CONTRACT ADDENDUM NO. 1
To the Contract Provisions for
CITY OF MOUNT VERNON PROJECT#
TS-2020-002: 2020 STREET IMPROVEMENTS

DATE OF ISSUE: MARCH 27, 2020

Item No. 3: DEPTH OF PAVEMENT AND ROAD EX

STANDARD DETAIL	3-4
SCALE	NONE
REVISION DATE	04/16

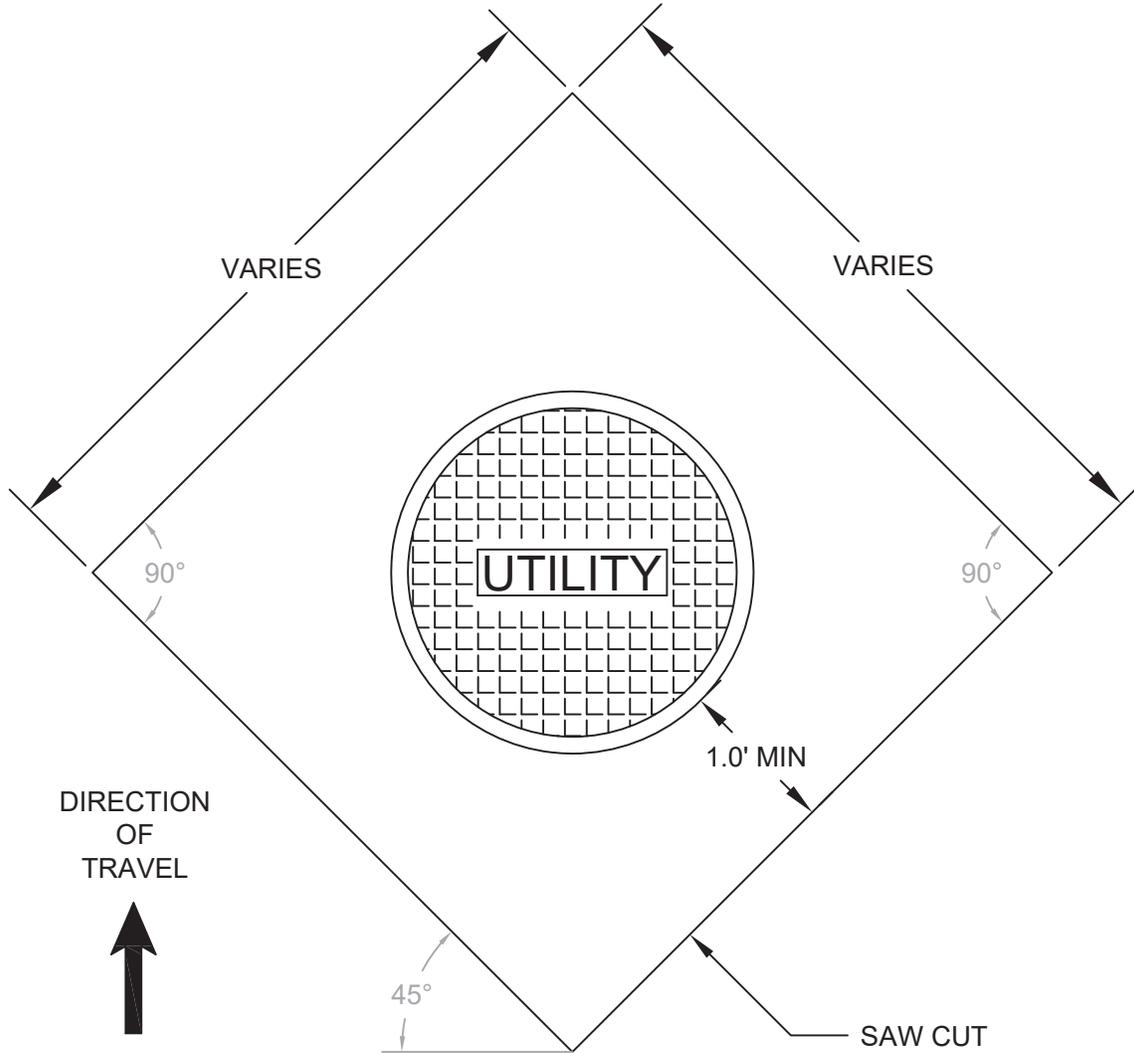
Item No. 4: STANDARD PLAN FOR ADJUSTMENT OF MANHOLE RING AND COVER

Standard Detail 3-4 for adjustment of manhole ring and cover is attached and made part of the contract.
